**A REVIEW OF THE HYDROGEOLOGY ELEMENT OF THE
LOCHELBank WIND FARM ENVIRONMENTAL
STATEMENT**

November 2005

Derek Ball

Figure 2: Superficial deposits

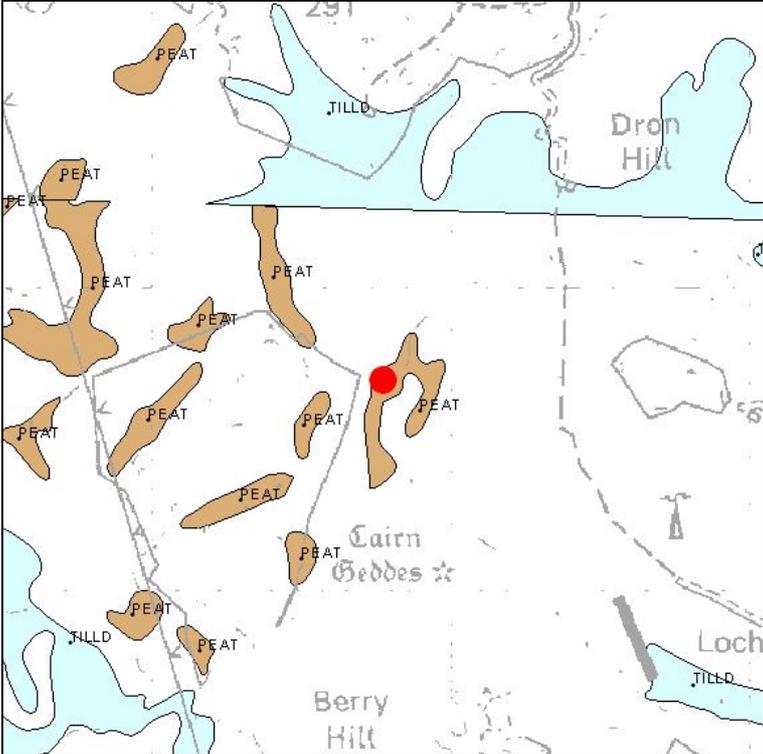
The straight-line feature seen in the northern part of Figure 2 represents the boundary between BGS Geological Sheet No. 48W, to the north, and Sheet 40W to the south. Clearly, differences in mapping techniques have resulted in the recording of large areas of till to the north whereas to the south, across much of the project area, no deposits are mapped. It can be assumed, however, that till forms a more extensive deposit than indicated on the map for the project area, but the details are currently unknown.

Both sections require further detail as to the nature and distribution of the superficial deposits, particularly as the southern BGS geological sheet is lacking in detail compared to the northern one.
